# Addendum Number 01

To Drawings and Specifications dated March 10, 2024

**2024 Watkins & Rowe MS and Cy Park HS Renovations**  
**Cypress Fairbanks Independent School District**  
**CFISD Proposal Number: 24-02-5753-R-RFP**

PBK Project No's.: 240058/240059

**04** ENLARGED PLAN - CANOPY  
1/8" = 1'-0"

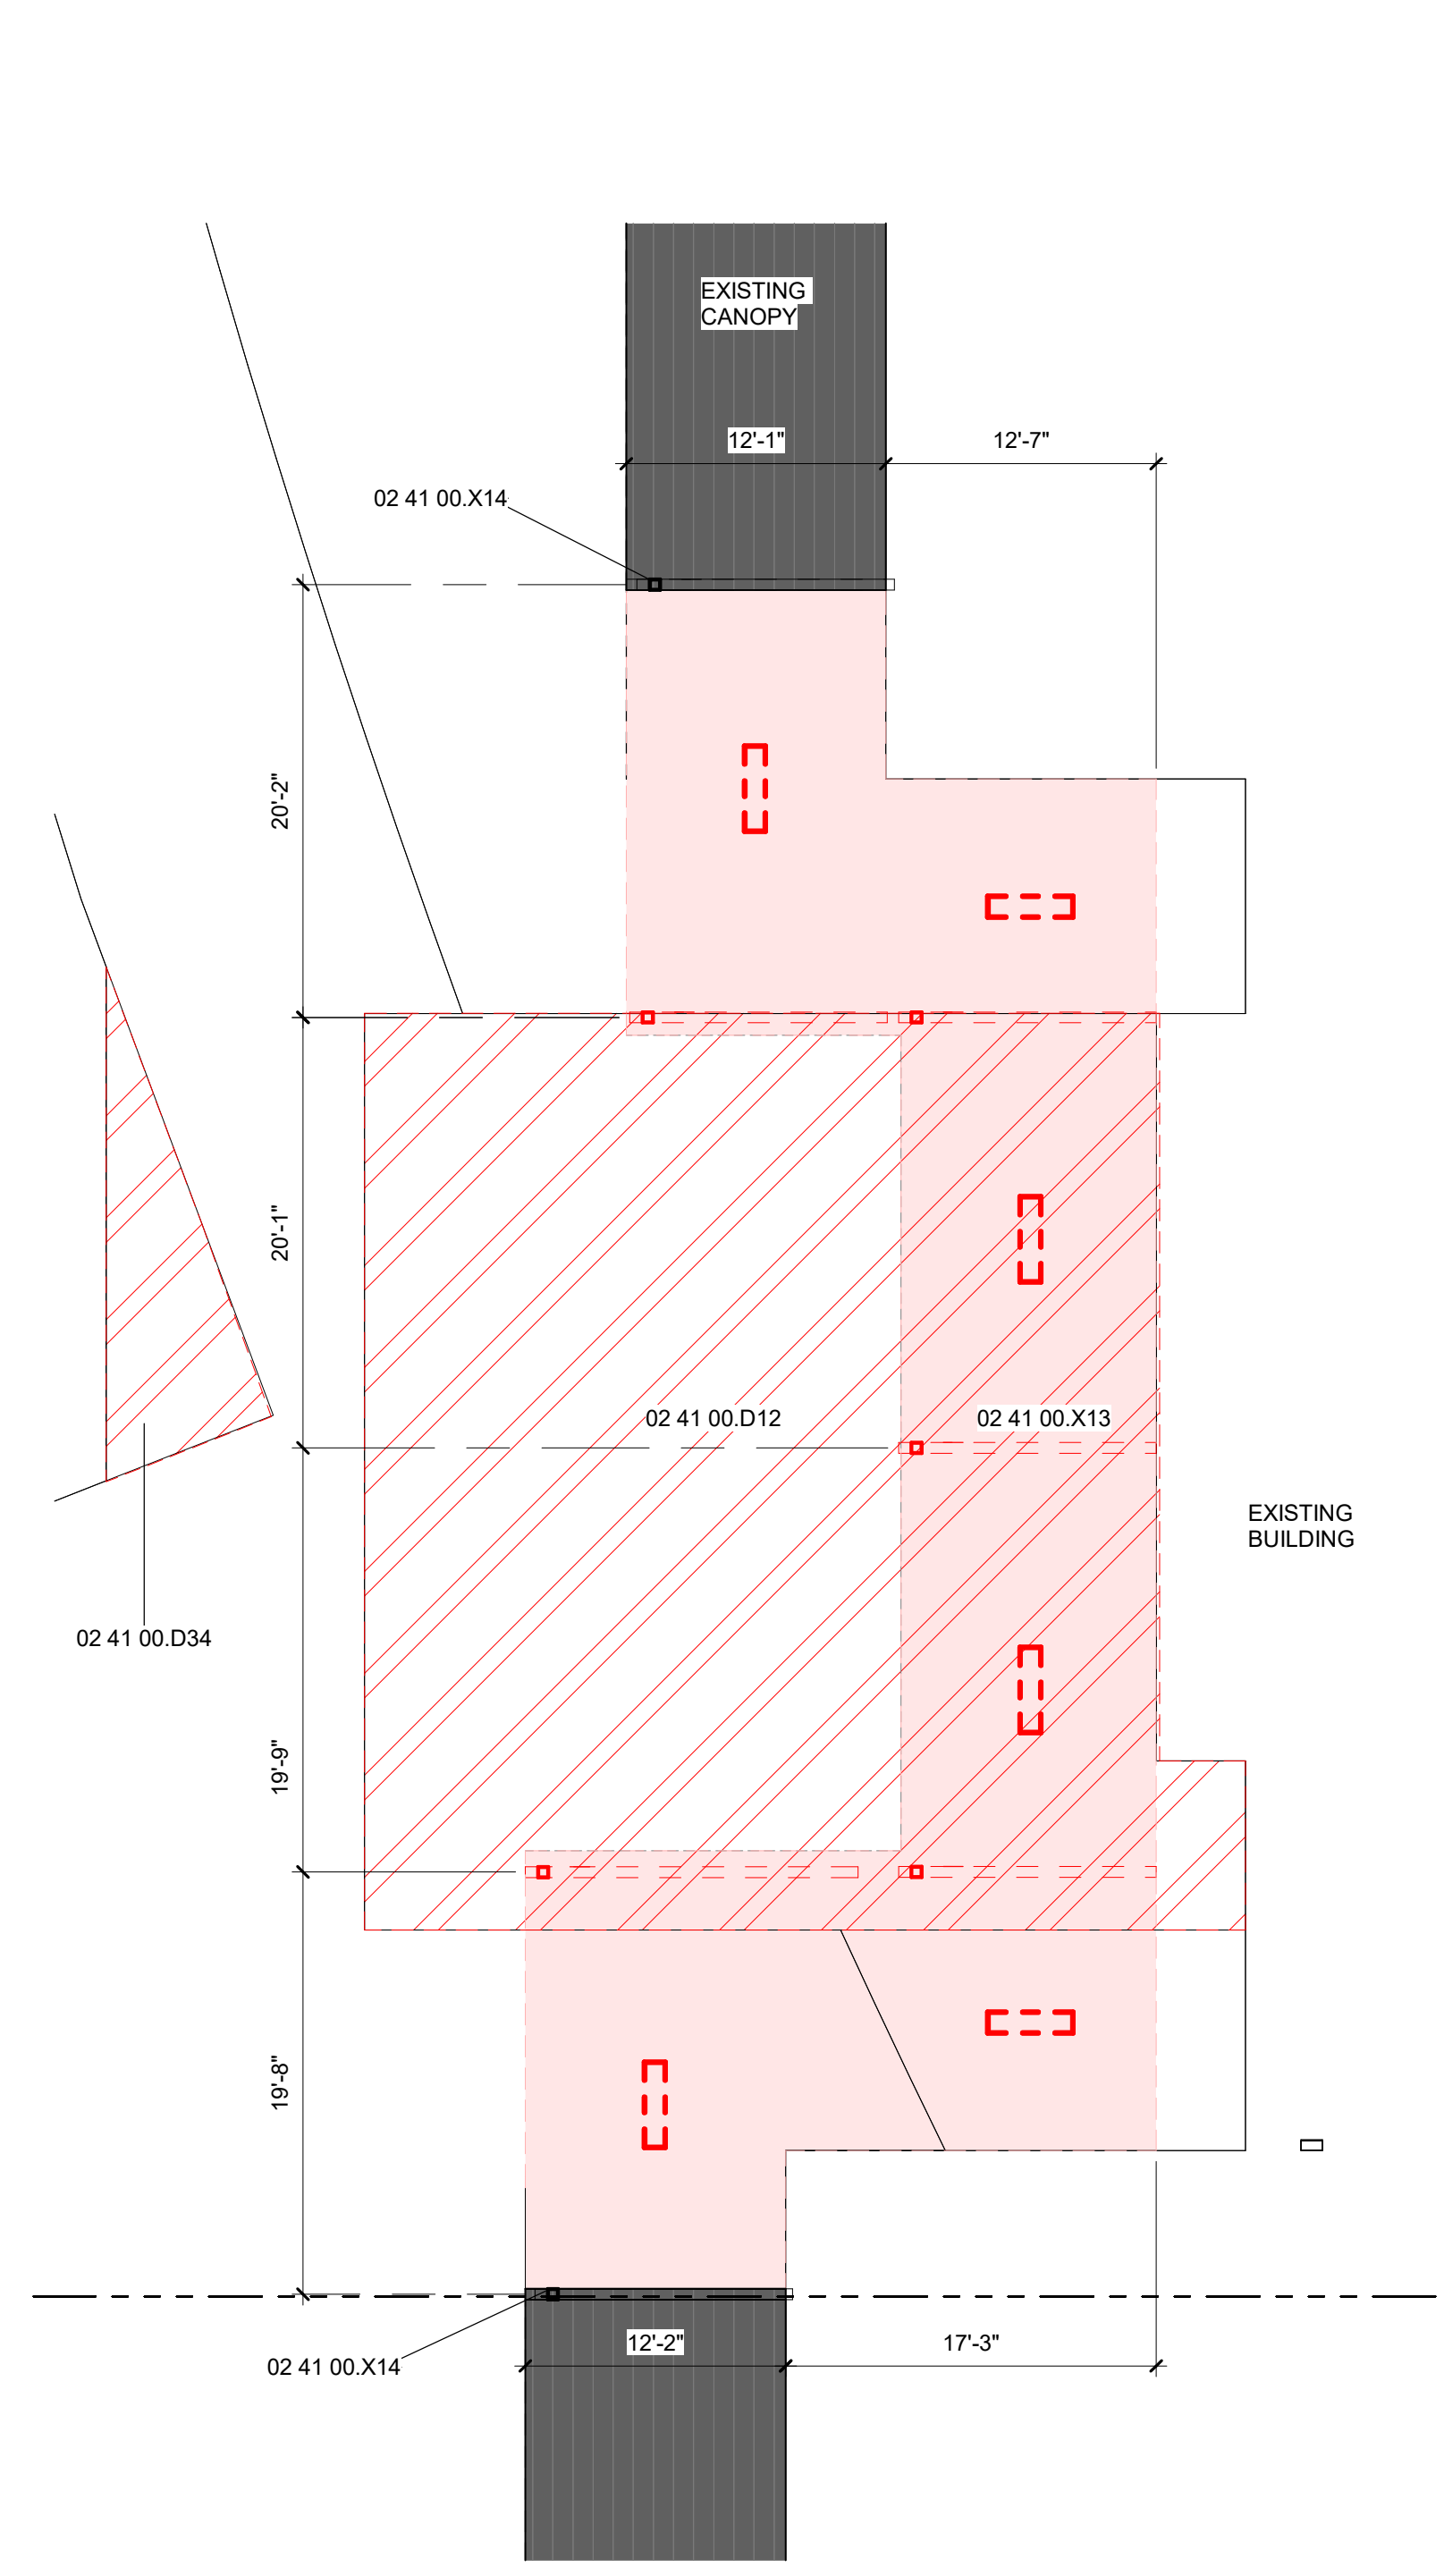
- Item No. 26** Sheet AS-401 - ENLARGED SITE PLAN  
A. Added note to provide flashing between new canopy and existing adjacent wall at 04/AS-401.  
B. Added note for GC to coordinate canopy end cap and flashing between new and existing aluminum canopy system at 04/AS-401.

**30** COMPOSITE EXTERIOR ELEVATION - ORCHESTRA ADDITION  
1/16" = 1'-0"

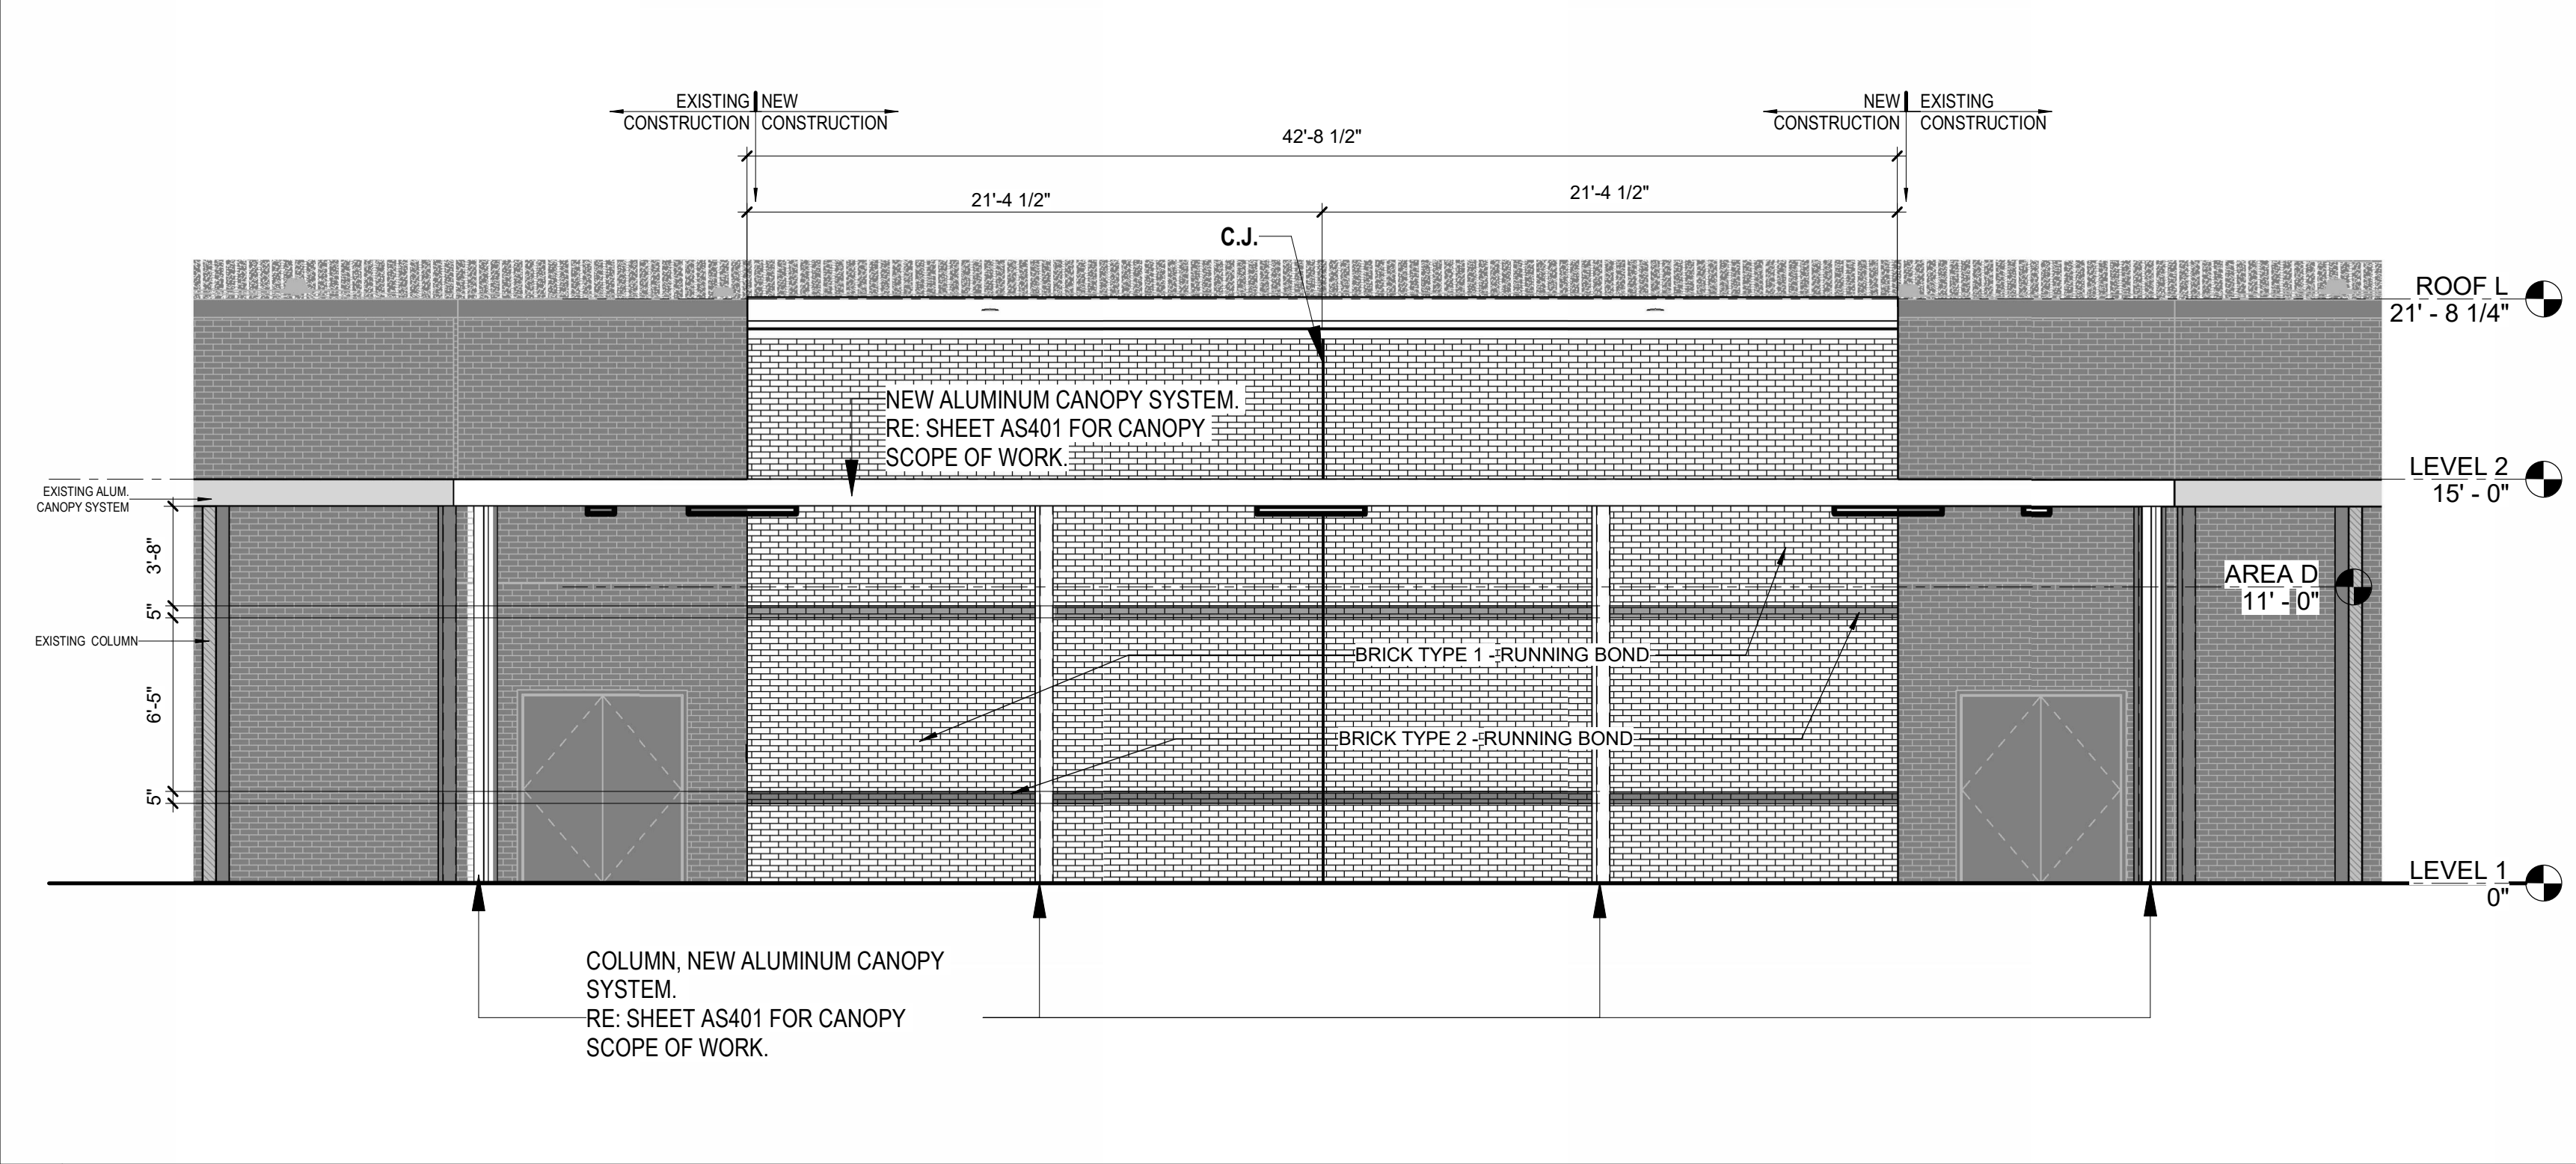
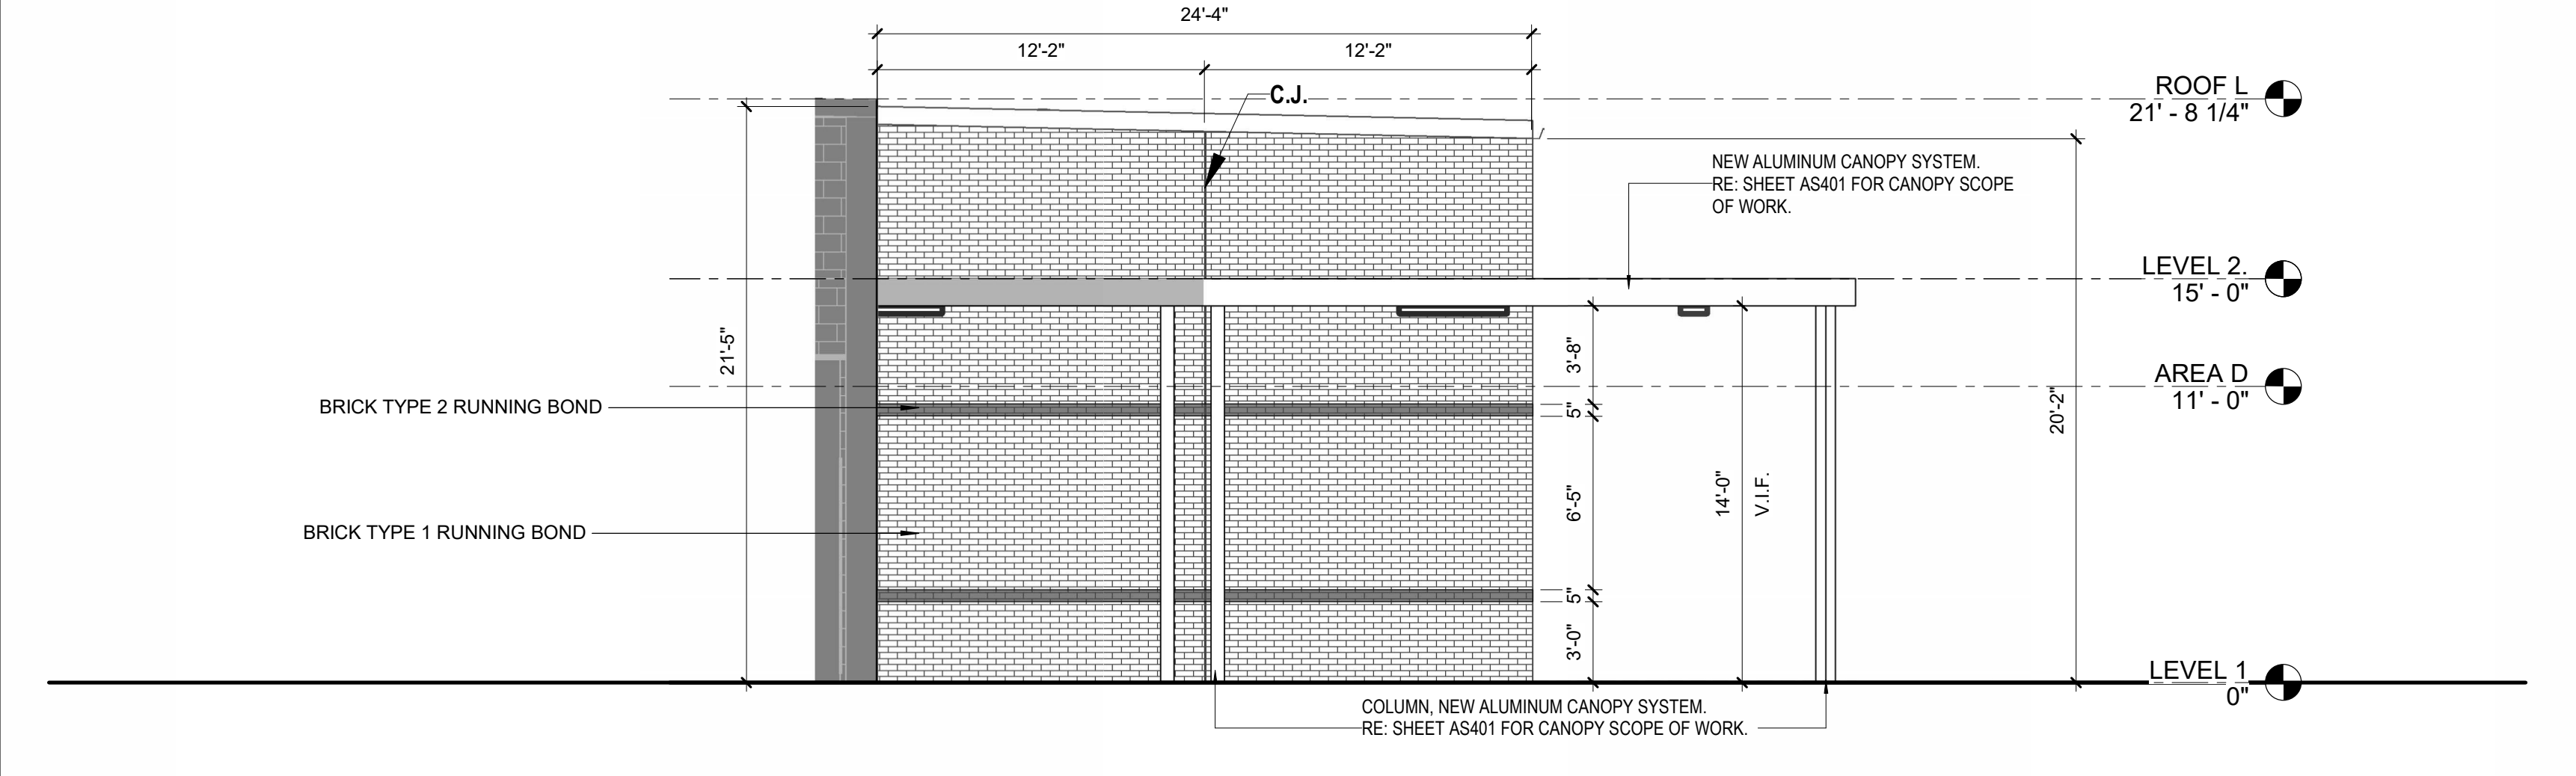
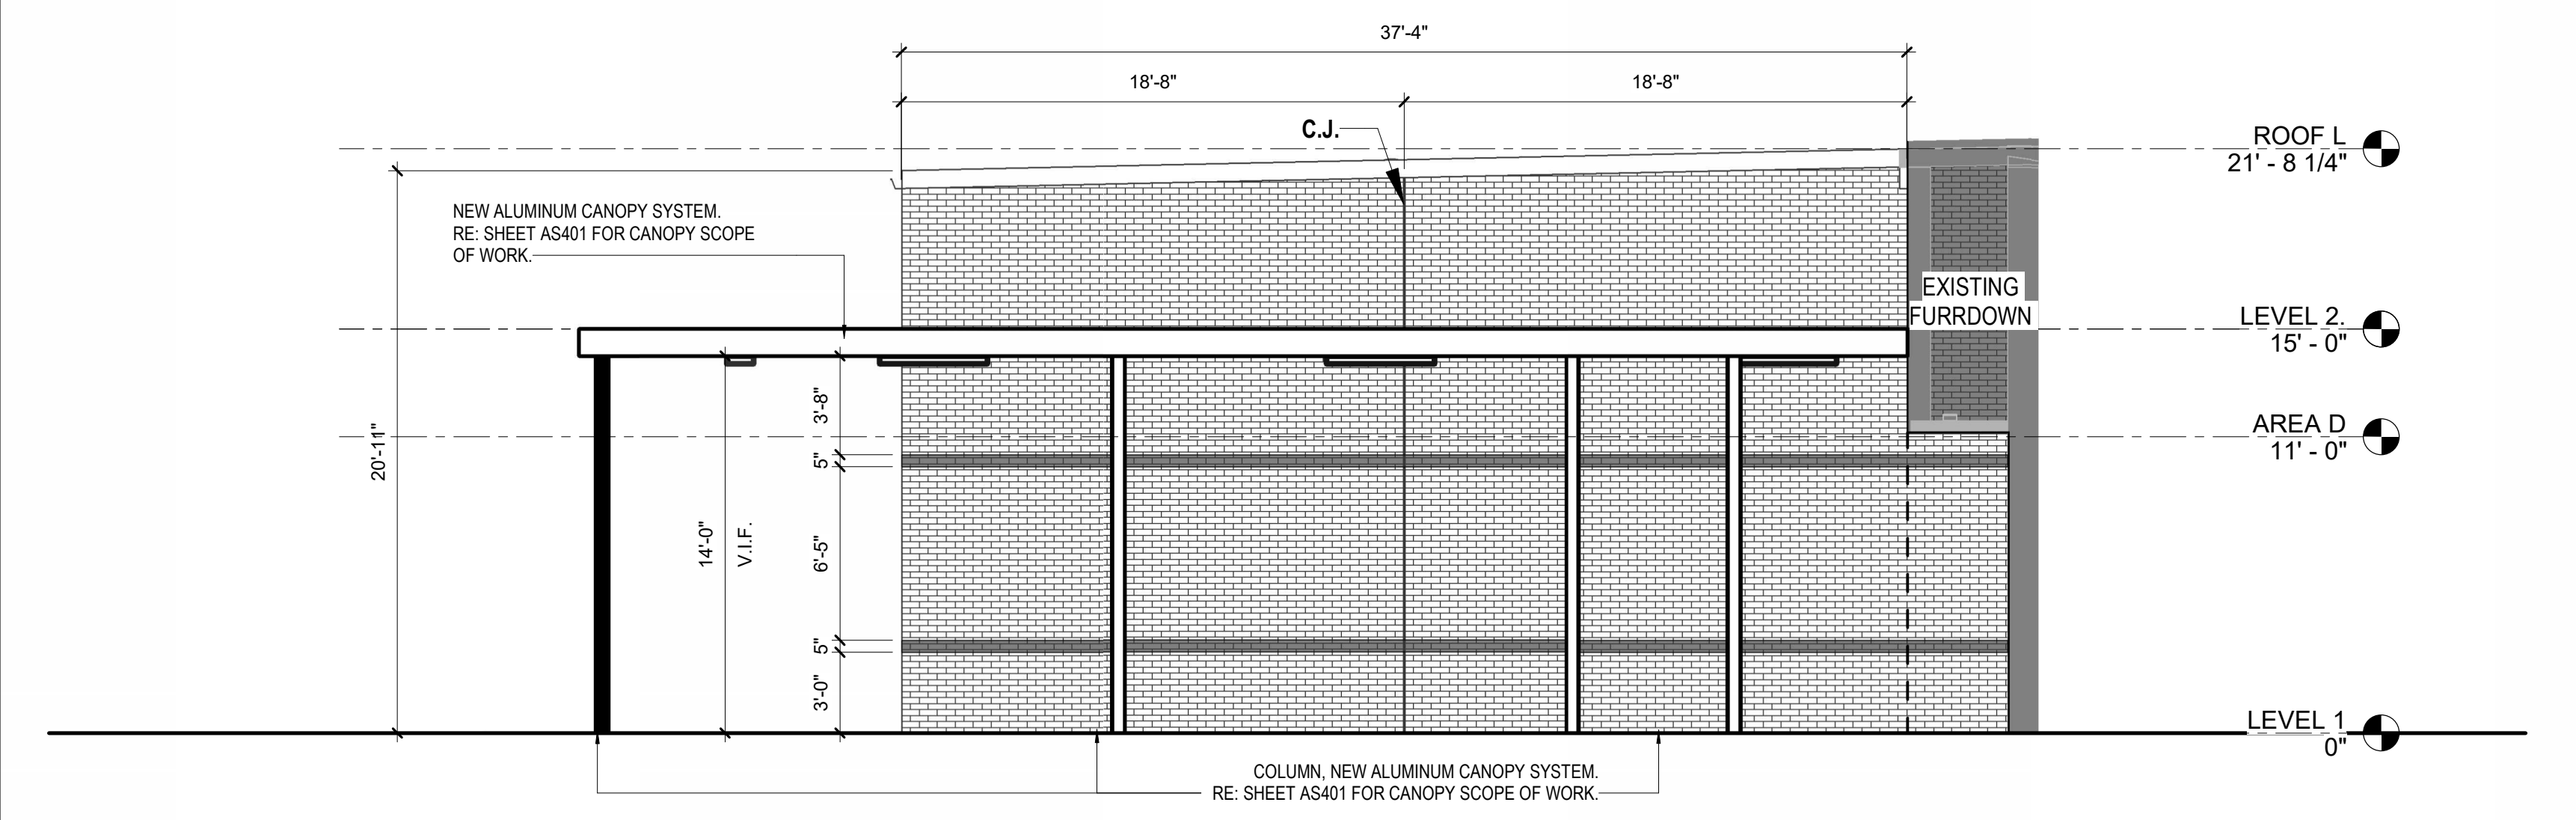
- Item No. 35** Sheet A-501 – EXTERIOR ELEVATIONS – COMPOSITE & ENLARGED  
A. Updated Existing/New Construction tags that were conflicting at 30/A-501.
- Item No. 36** Sheet A-521 – INTERIOR ELEVATIONS
